Planning & Zoning Board

Thursday, January 16, 2025

1. App# 2024-0630; 2467 Taylor Square Dr.; Kush Patel for 256 Hotel Group, LLC; Variance
2. App# 2024-0629; 2467 Taylor Square Dr.; Kush Patel for 256 Hotel Group, LLC; Conditional Use

DATE	
REVISIONS	
NO	
DRAWN BY:	CHECKED BY:
JS	SF
SCALE:	1" = 30'
DATE:	12/18/2024
SHEET NO.	C-1

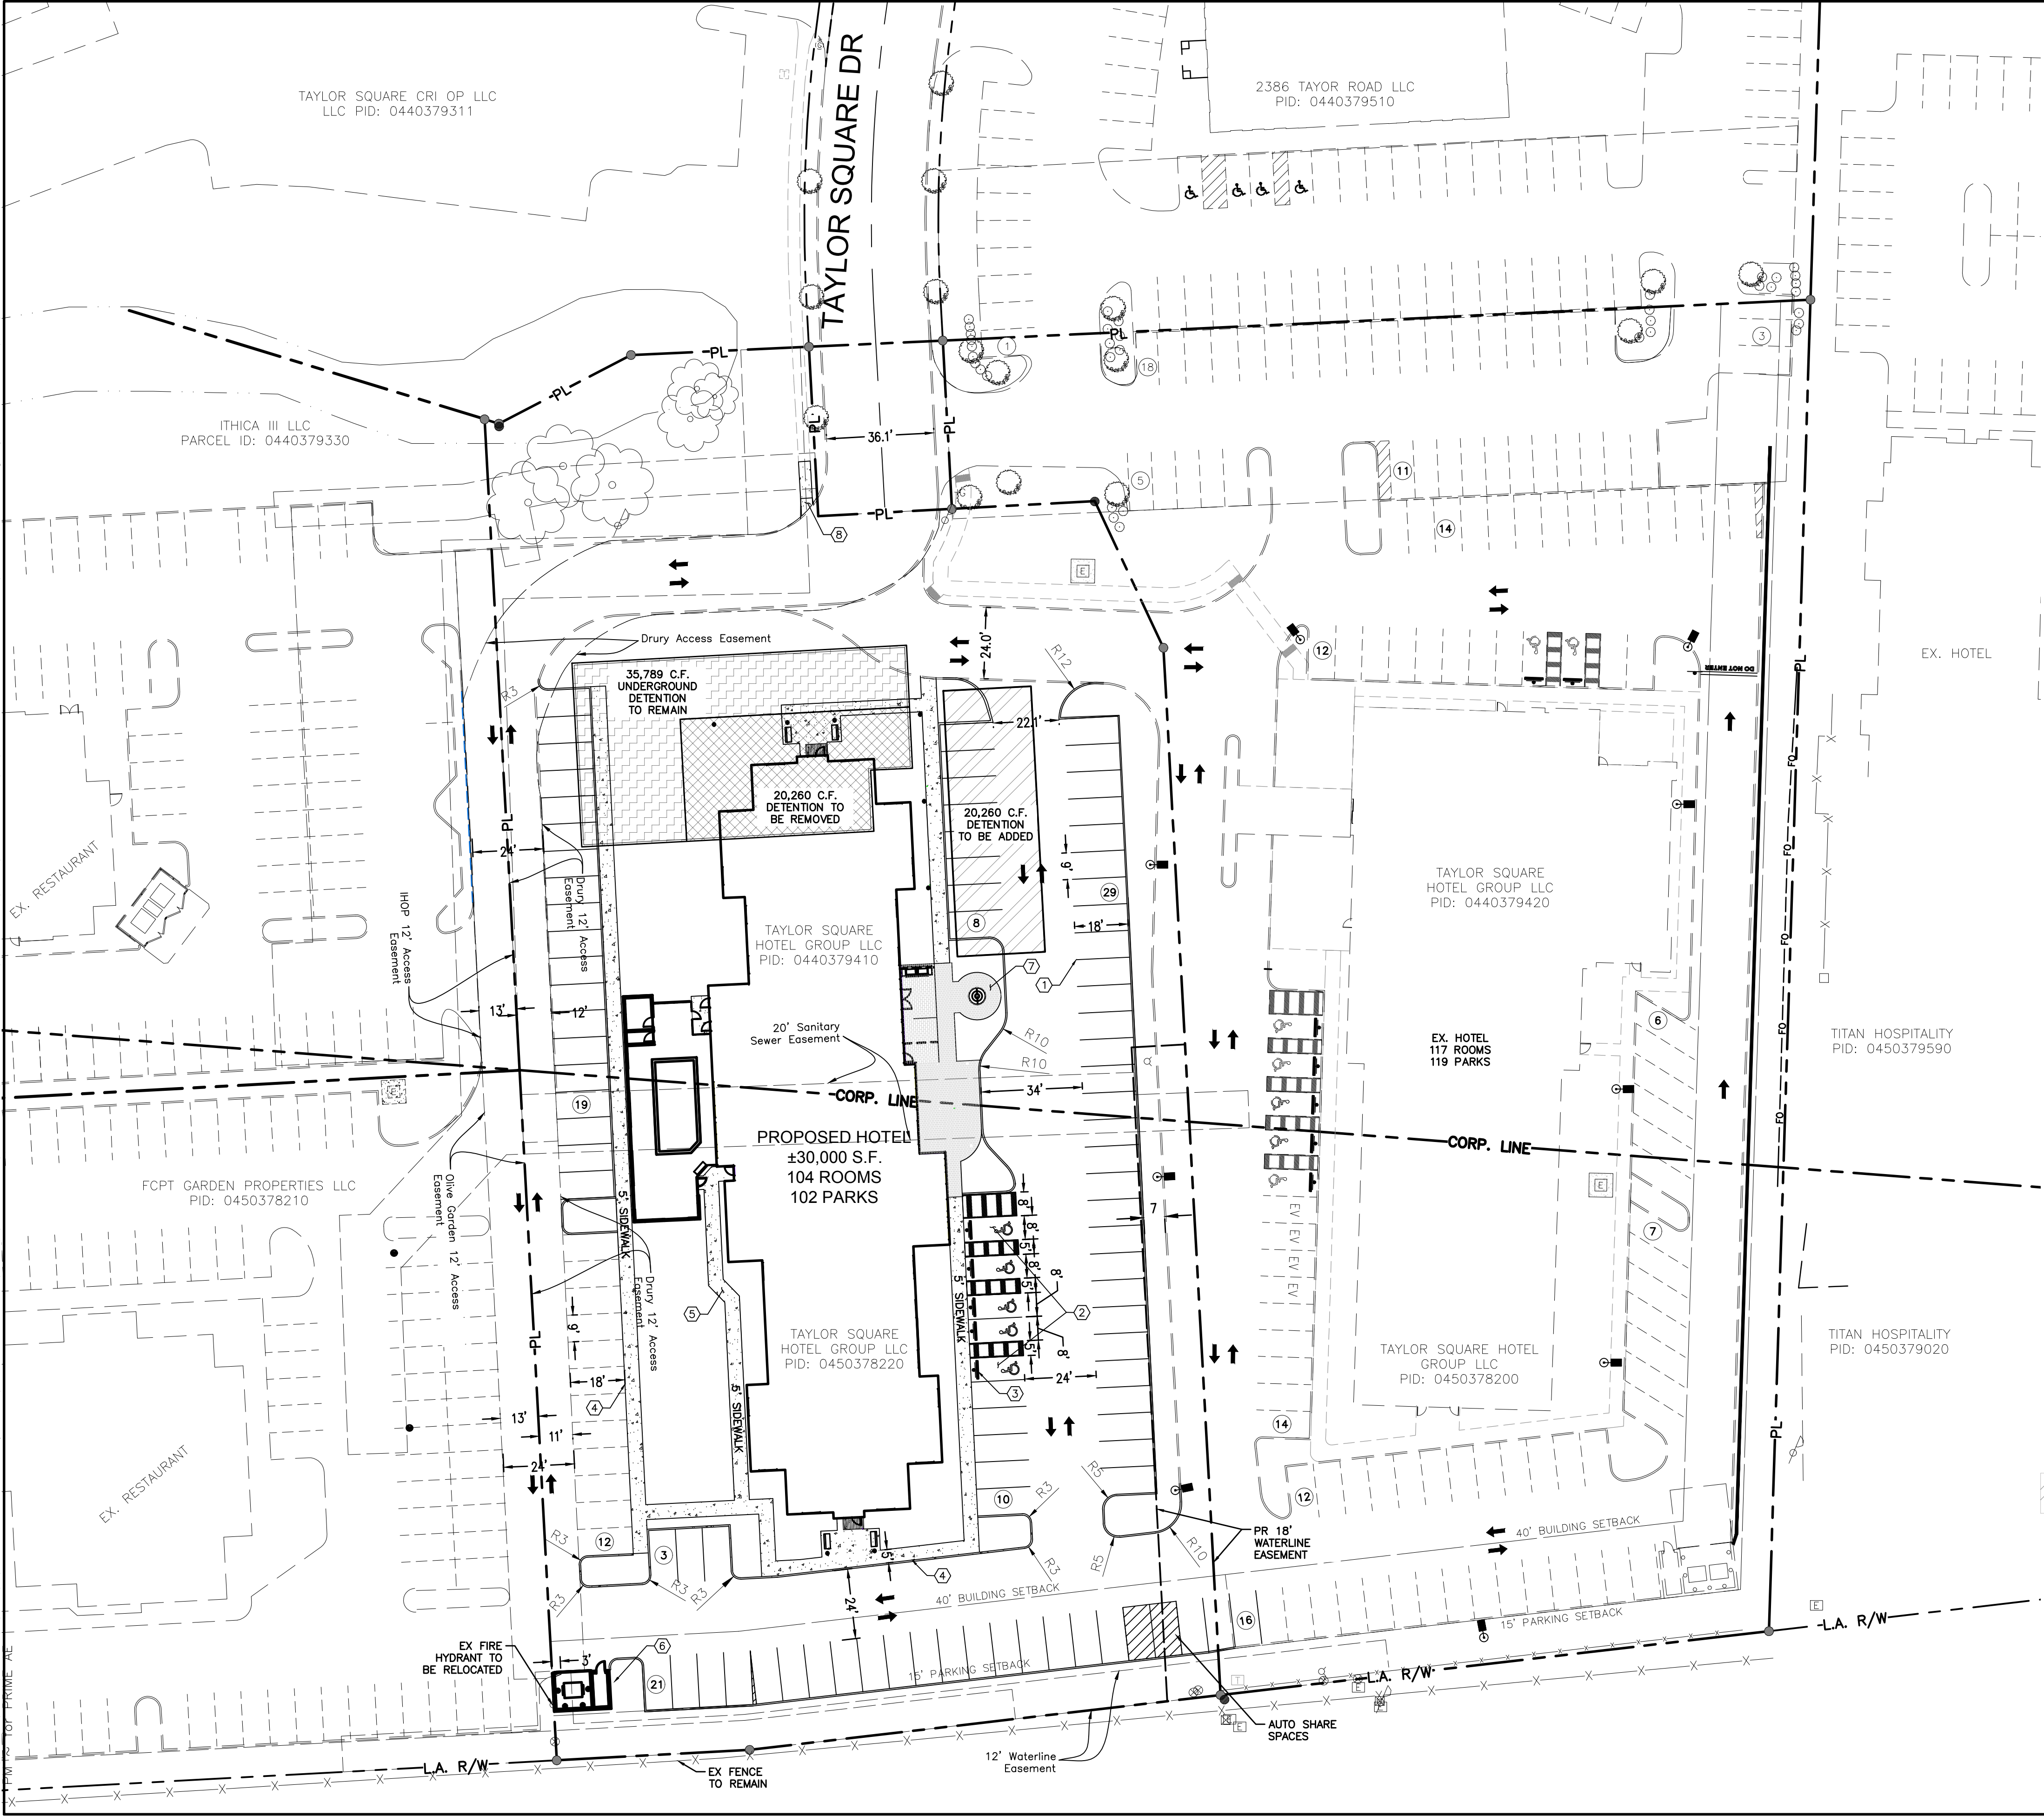
2. Staff however feels that the required parking lot islands could be provided by the applicant without needing a variance from the code. The auto share standards allow up to 4 parking spaces to be reduced for every auto share parking space provided on the site, not exceeding 10% of the required number of parking. With 104 parking spaces required on the subject site a maximum of 10 parking spaces could be reduced on the site, with a total of 94 parking spaces provided. The applicant shows 101 parking spaces on the site. The applicant could reduce some of the parking spaces to provide the additional 3 parking lot islands on the subject site.

- b. Staff however recommends denial of the requested variance to Section 1105.07.J.ii to reduce the number of parking lot islands from 11 to 8, due to the parking lot island being able to be provided with the reduction of a few parking spaces, due to the applicant utilizing the auto share standards to reduce parking, which could be reduced by a few more spaces to provide the required parking lot islands on the site. Staff also recommends denial, due to granting the variance would set a precedence in other commercially zoned areas of the city, along with providing special privileges to this parcel. Staff believes the variance is not necessary and the required parking lot islands could be achieved on site without the requested variance.

1. The site plan shows two access points to the north. The 24-ft wide main access point is located at Taylor Square Drive directly in front of the parcel, and the second is an auxiliary access which connects to the parking lot of the BW3 restaurant, northeast of the proposed site. The auxiliary access is also shared with the Home2Suites hotel directly to the east of the proposed project. There are no traffic signals in this area except at the dead end of Taylor Square Drive at Taylor Road to the north. All roadways and access points are sufficient.

2. Based on the Site Plan, there are a total of 102 parking spaces including 5 ADA spaces at the east side of the structure.
3. The site includes a 24-ft access drive around the perimeter of the property. On the west side of the building access drive includes an access easement the between Olive Garden parcel and one of the proposed parking areas for the proposed hotel. The access drive is located 11 feet on the proposed site and 13' on the Olive Garden parcel initiating the variance. Although the Site Plan does not specifically call out two-way traffic around the perimeter of the hotel, the width of the access drive at 24-ft (between parking spaces) would be sufficient for two-way traffic.

6. The Site Plan indicates that presently, the parcel has an underground detention unit (on the north side of the property) for a total of 38,589 cubic feet of storm water capacity. The proposed plan would remove a portion of the unit 20,260 cubic feet of capacity. A new underground detention unit would be constructed on the east side of the hotel with a capacity of 20,260 cubic feet, for a total of 56,046 cubic feet of capacity at completion of the project. It is unclear if the combined detention unit are adequate for the proposed site. A stormwater report will need to be submitted on future reviews to ensure the required stormwater capacity for the area is in place during and after construction.

DATE	
REVISIONS	
NO	
DRAWN BY:	CHECKED BY:
JS	SF
SCALE:	1" = 30'
DATE:	12/18/2024
SHEET NO.	C-1

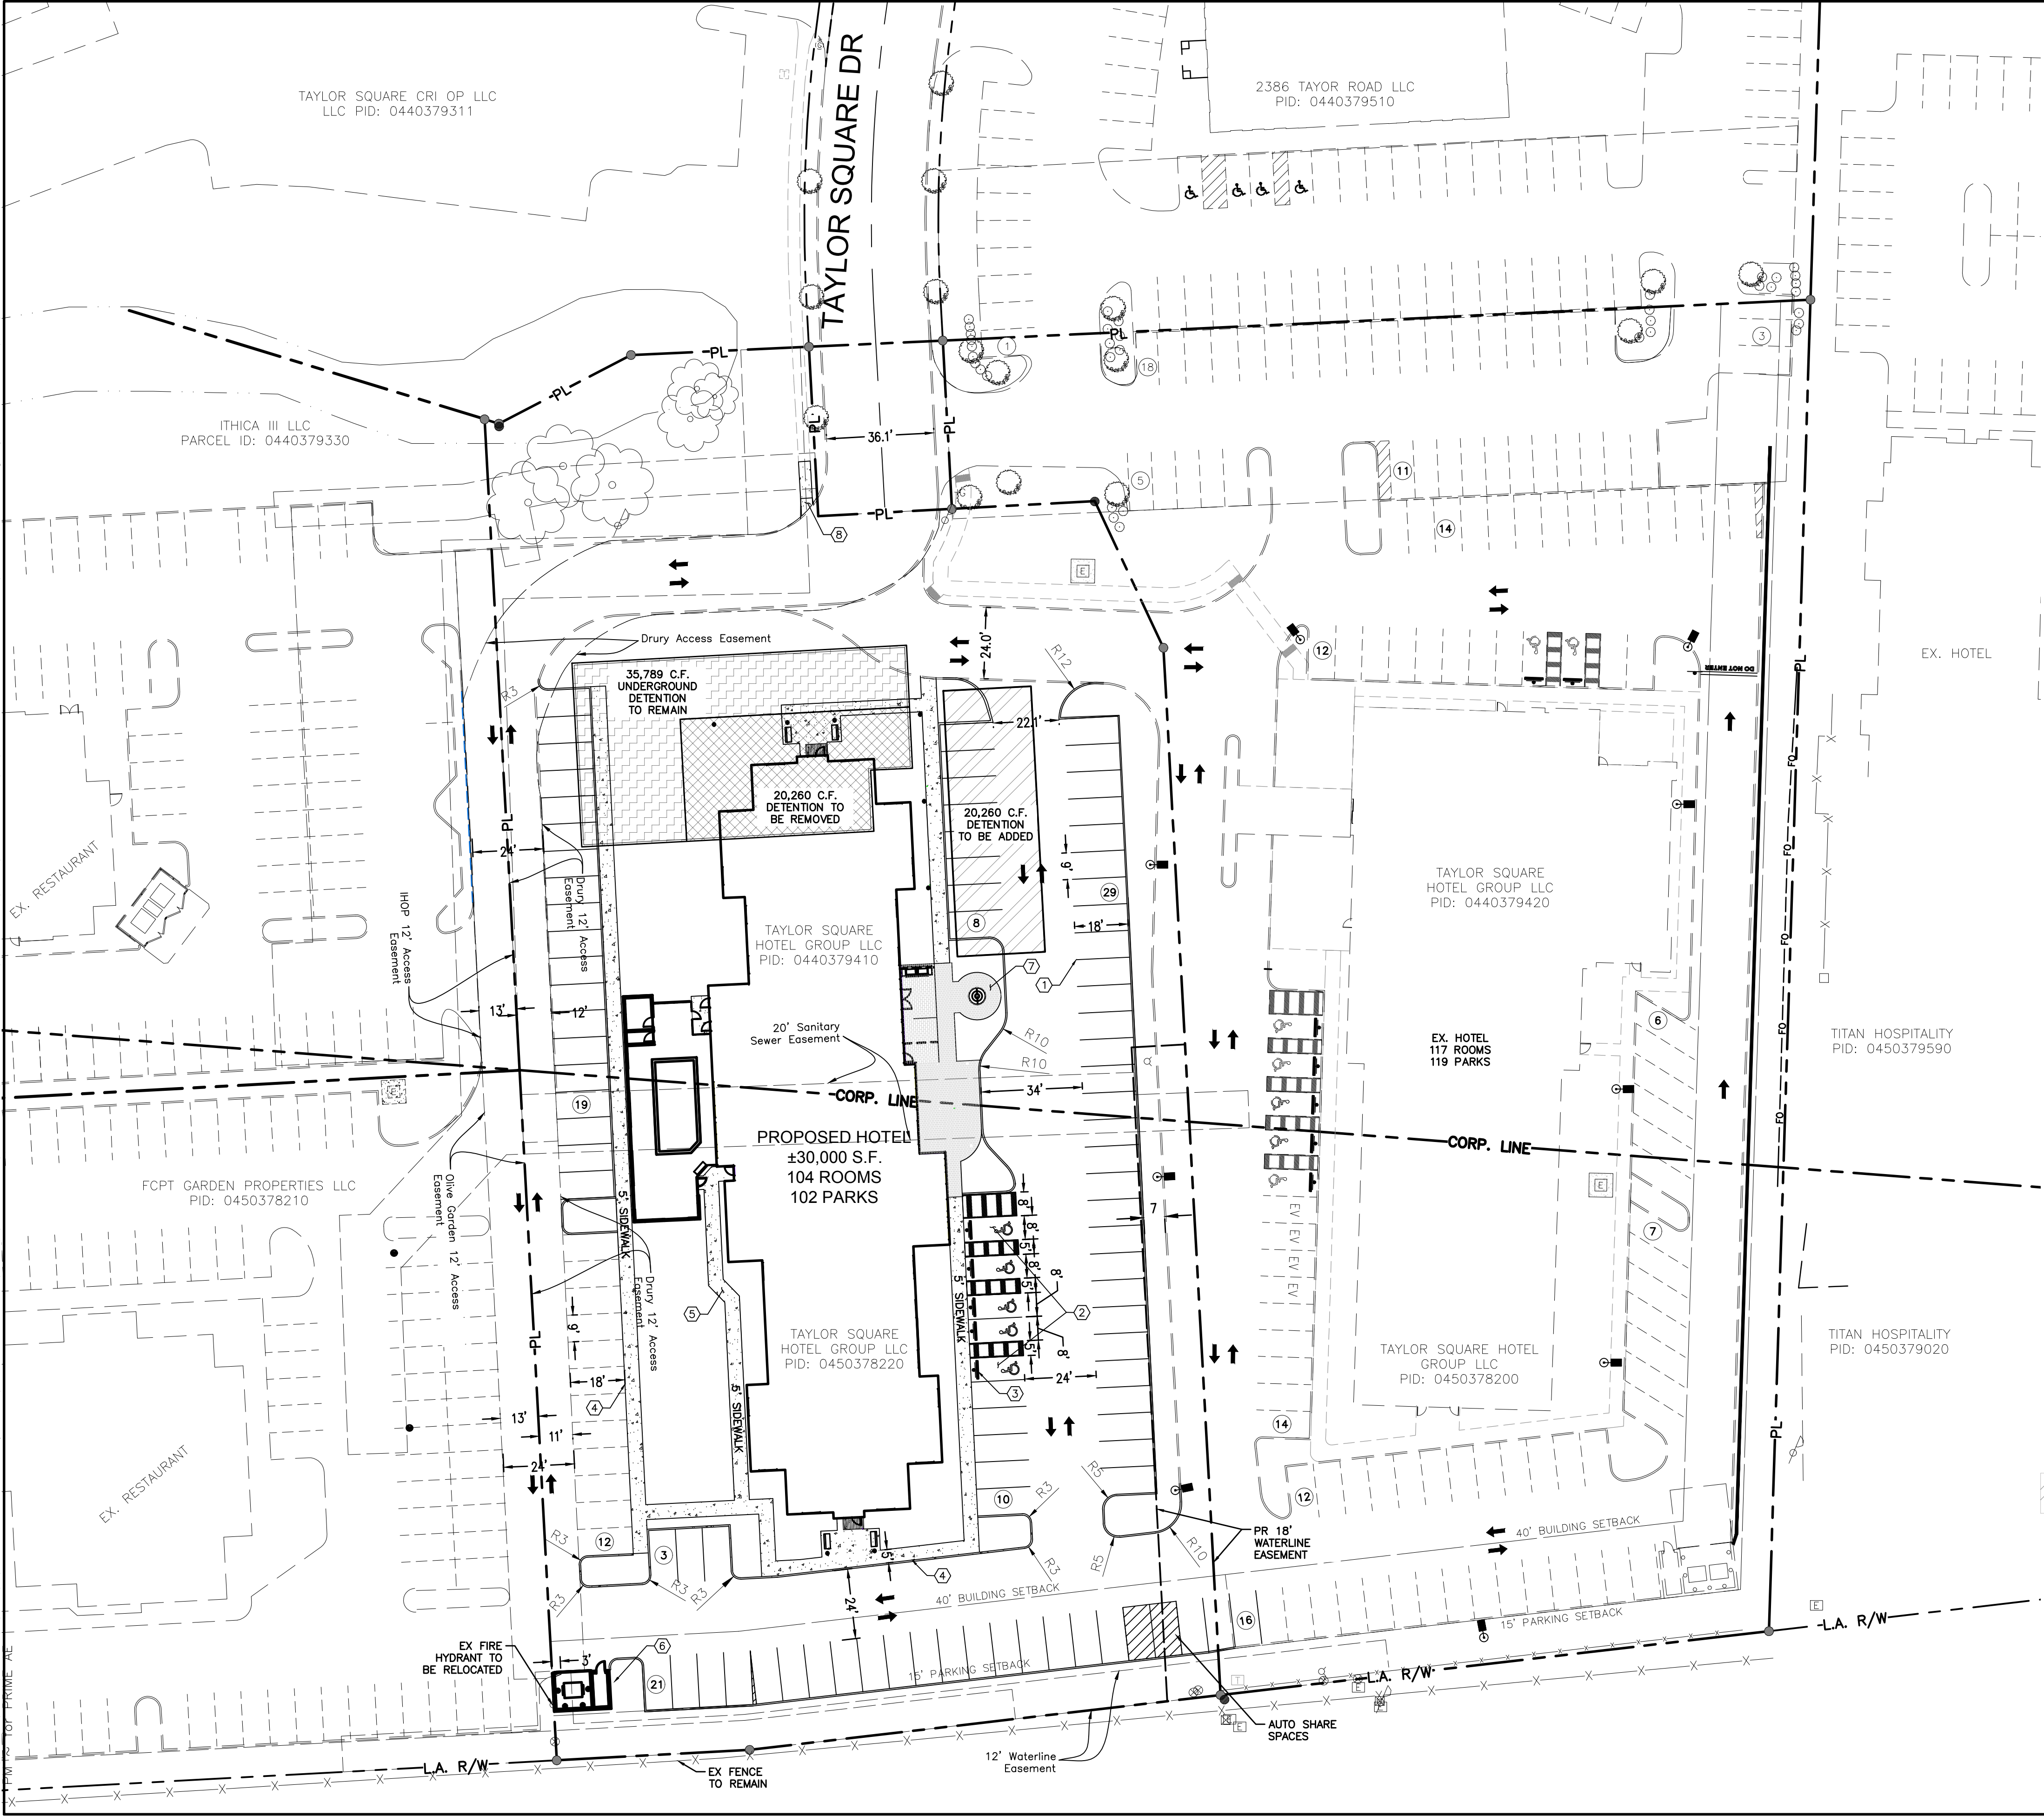
- a. The applicant has provided a total of 102 parking spaces on-site, including 100 regular parking spaces and 2 auto-share parking spaces. The applicant has also provided an auto-share parking plan that shows that the auto-share parking spaces will be designated with signage. With the 2 provided auto-share parking spaces, the applicant has received an off-street parking requirement reduction from 104 spaces to 102 spaces. Since a total of 102 parking spaces are proposed on the applicant's site plan, staff finds that the applicant has met the off-street parking requirements.

1. The site plan shows two access points to the north. The 24-ft wide main access point is located at Taylor Square Drive directly in front of the parcel, and the second is an auxiliary access which connects to the parking lot of the BW3 restaurant, northeast of the proposed site. The auxiliary access is also shared with the Home2Suites hotel directly to the east of the proposed project. There are no traffic signals in this area except at the dead end of Taylor Square Drive at Taylor Road to the north. All roadways and access points are sufficient.

2. Based on the Site Plan, there are a total of 102 parking spaces including 5 ADA spaces at the east side of the structure.
3. The site includes a 24-ft access drive around the perimeter of the property. On the west side of the building access drive includes an access easement the between Olive Garden parcel and one of the proposed parking areas for the proposed hotel. The access drive is located 11 feet on the proposed site and 13' on the Olive Garden parcel initiating the variance. Although the Site Plan does not specifically call out two-way traffic around the perimeter of the hotel, the width of the access drive at 24-ft (between parking spaces) would be sufficient for two-way traffic.
